NATIONAL FIRE PROTECTION ASSOCIATION

M E M O R A N D U M

SUBJECT: NEC® Second Draft TC FINAL Ballot Results (A22)

Second Revision No. 8154-NFPA 70-2021 [Global Comment]

Figure 210.52(C)(1) Determination of Area Behind a Range, Counter-Mounted Cooking Unit, or Sink.

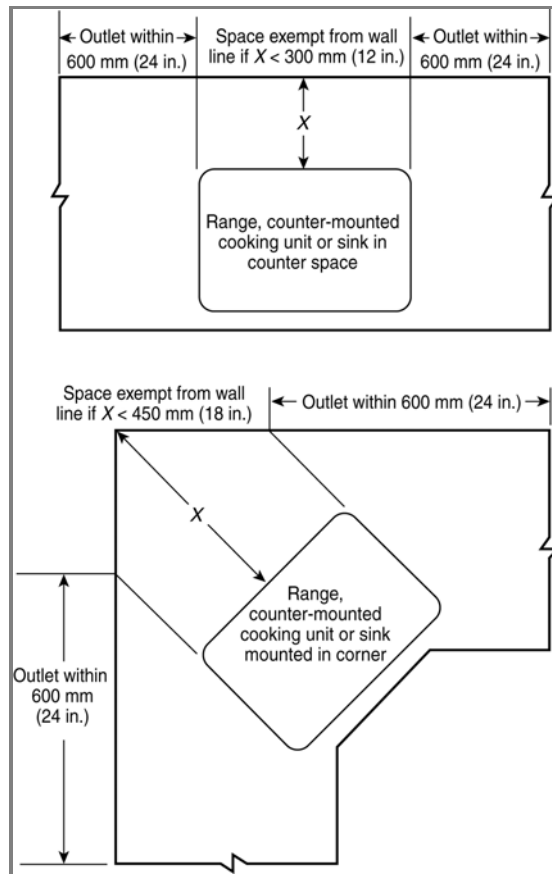
Exception No. 1: Receptacle outlets shall not be required directly behind a range, counter-mounted cooking unit, or sink in the installation described in Figure 210.52(C)(1).

Exception No. 2: Where a required receptacle outlet cannot be installed in the wall areas shown in Figure 210.52(C)(1), the receptacle outlet shall be permitted to be installed as close as practicable to the countertop area to be served. The total number of receptacle outlets serving the countertop shall not be less than the number needed to satisfy 210.52(C)(1). These outlets shall be located in accordance with 210.52(C)(3).
